ADDENDUM NO. 1

SARATOGA VILLAGE PEDESTRIAN ENHANCENMENT PROJECT

FEDERAL PROJECT ID: CML-5332(013)

April 7, 2010

DETAILS

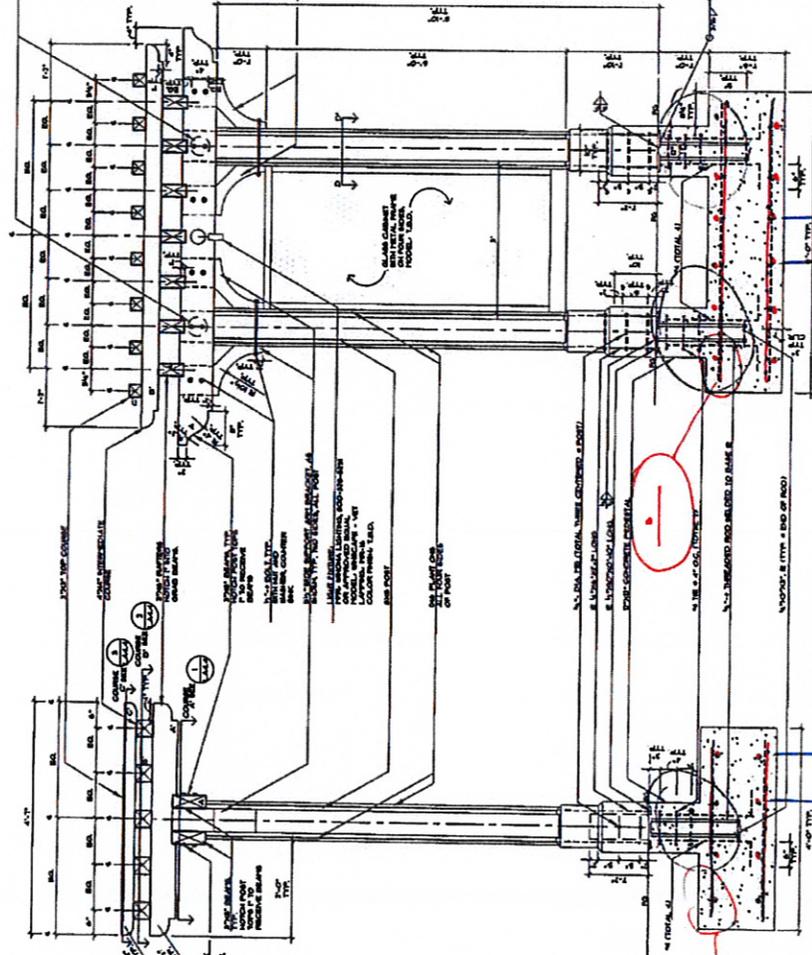
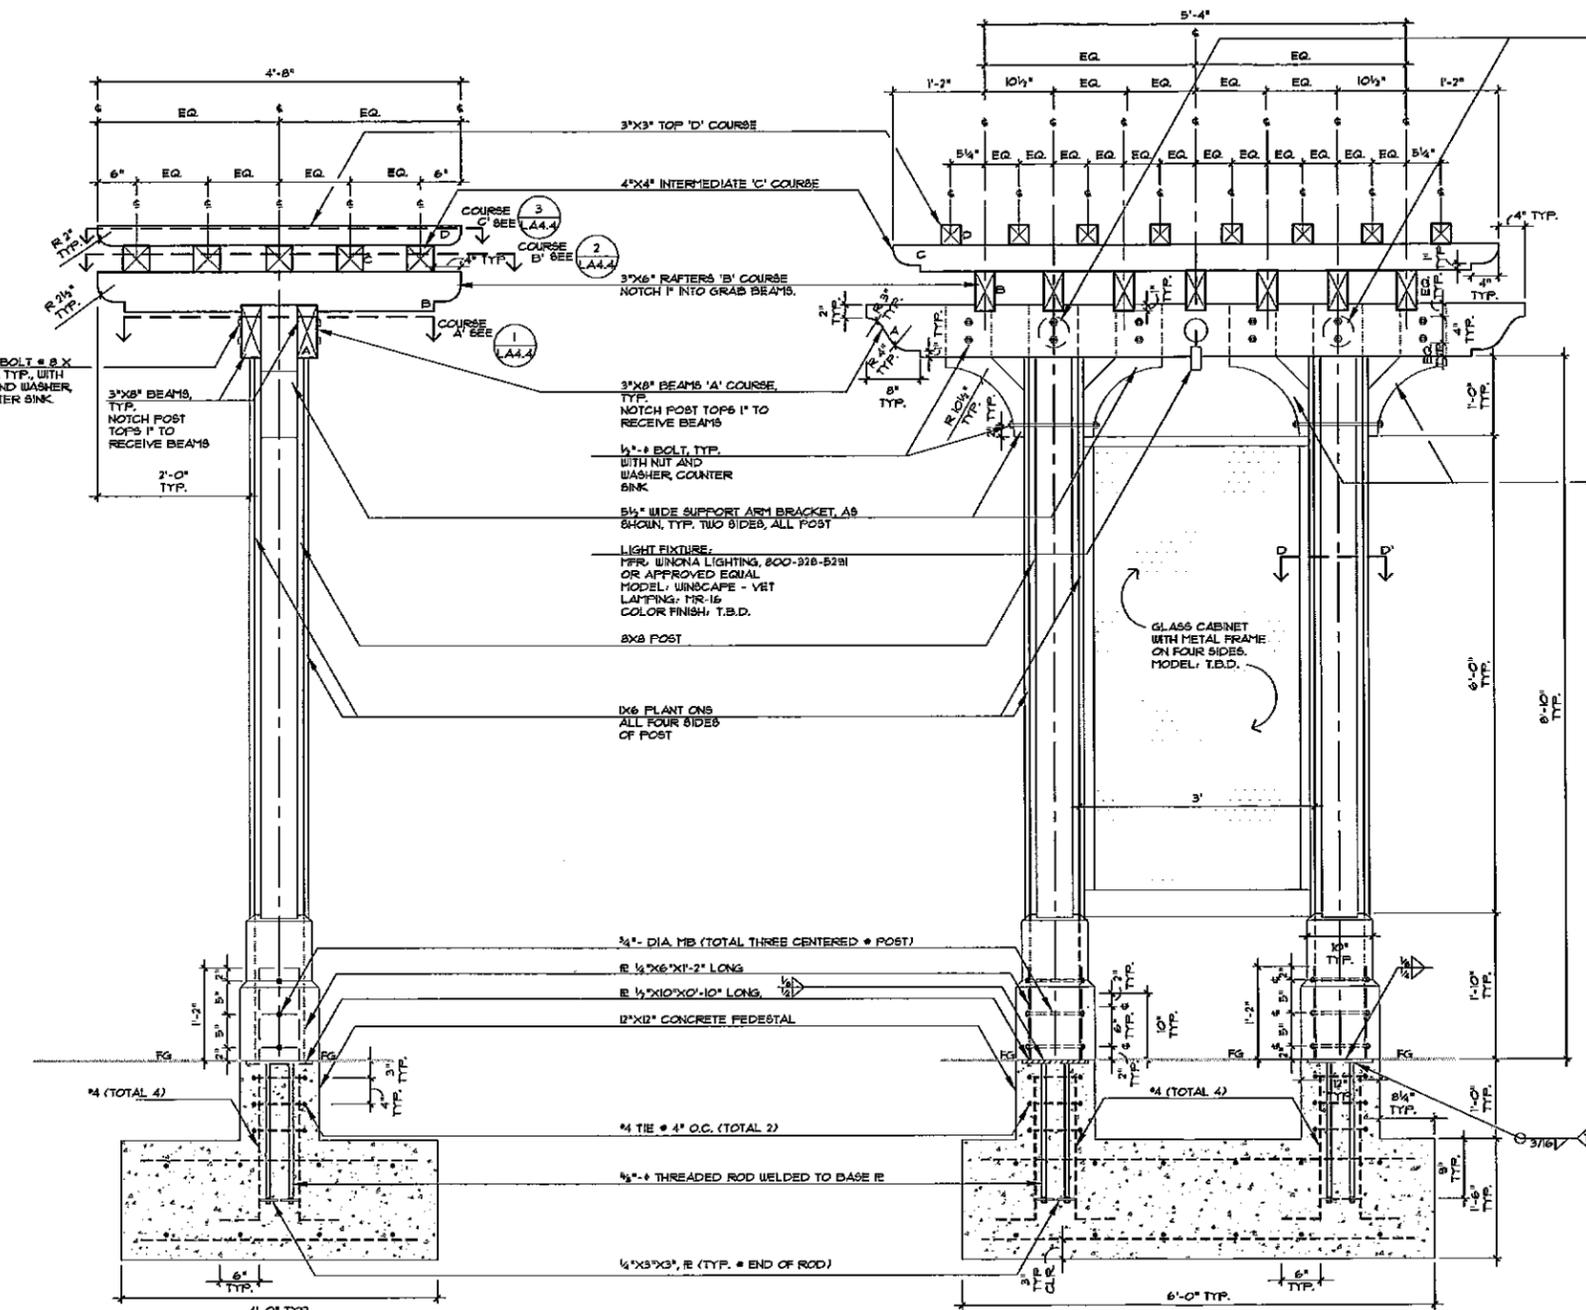
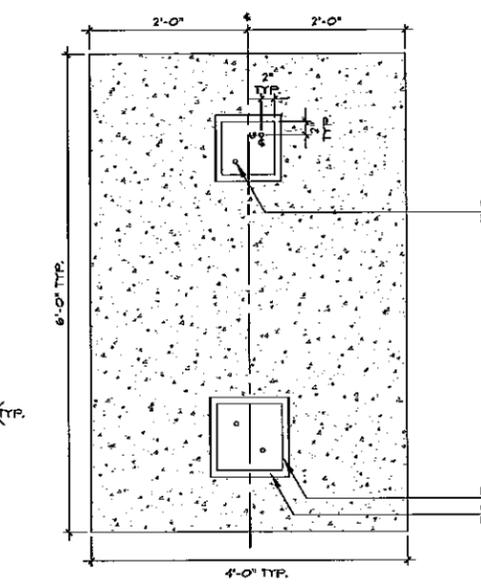
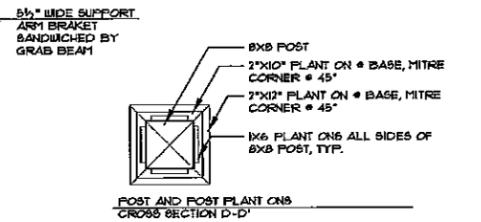
1. The details for the Kiosk have been changed from the contract plans. The attached new Kiosk details will consist of a two post detail instead of the four post detail shown on the contract plans. There will be two Kiosks in the project located at 3rd street and Blaney Plaza. Bid item # 4 "KIOSK" on page 64 has already reflected the anticipated change. In addition the attached red marked sheet for the Rebar in footing will be called out as #5 as shown on right. Rebar placement will be corrected and spaced at 12" interval.

ADDENDUM 1: CLARIFICATION OF STAMPED CONCRETE PATTERNS

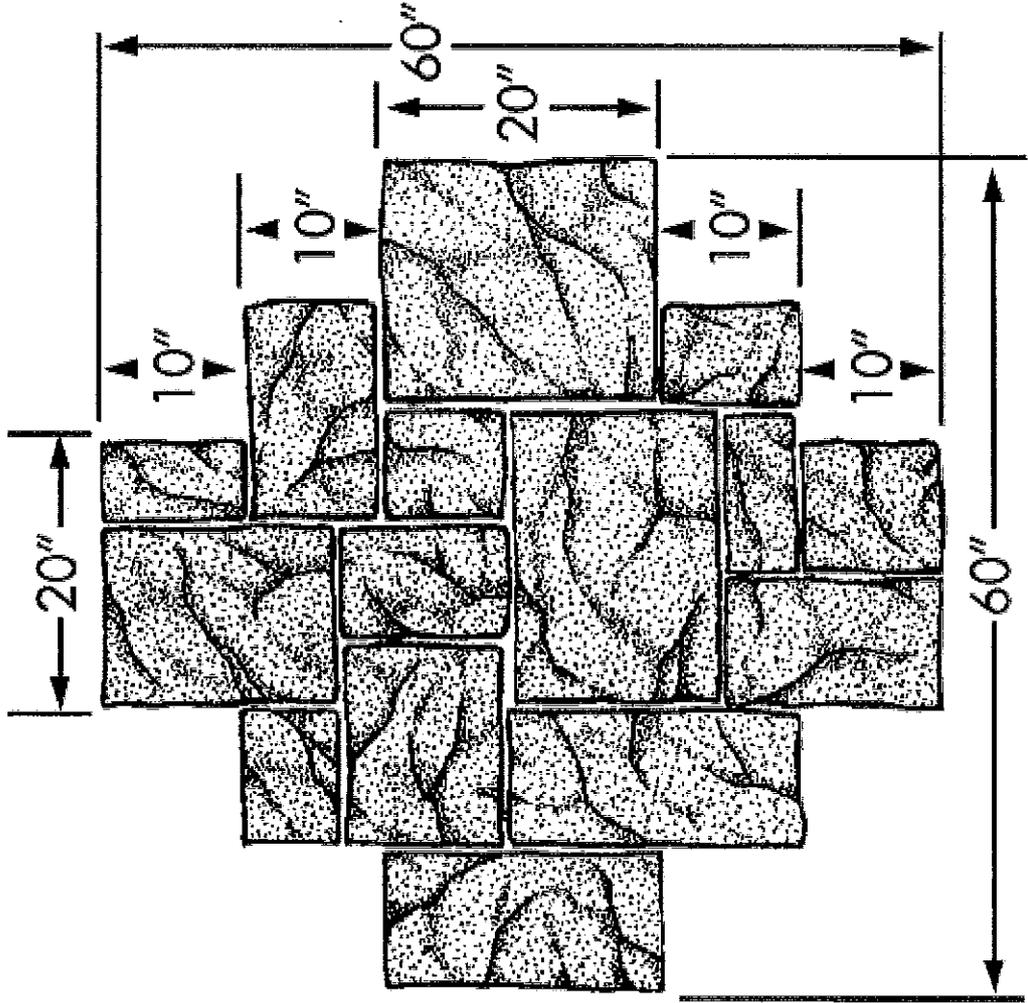
4. Clarification: The Contractor will provide surveying and staking at no additional cost to the City.
5. Clarification: Detail 7 on plan sheet LA4.1 illustrates interlocking pavers on concrete at median. The layout legend on LA1.0 calls for 4" cobblestone 3170 stamped concrete. Detail 7 is obsolete and has been removed from project, follow call out on sheet LA1.0.

6. On (Detail 3/C-2) there is no bid item for concrete bands. The Concrete Band labeled in Detail 3/C-2 should be labeled like the 8' crosswalk in detail, labeled as 6" PCC pavement. This is analogous/similar to the 12" wide stamped concrete bordering the 8' stamped concrete Pattern Cobblestone shown in landscape sheets. The Specs covering stamped concrete are Site Concrete. Accounted for in Bid Item #38 'Vehicular Toned Stamped Concrete at Crosswalk'.
7. The Vehicular Stamped/Toned Concrete Paving At Crosswalk by Schofield product will not be used and instead the Bomanite Product will be used or approved equal. The attached Ashlar pattern from Bomanite with the stamped gaps at max. 1/2" wide shall be used or approved equal.
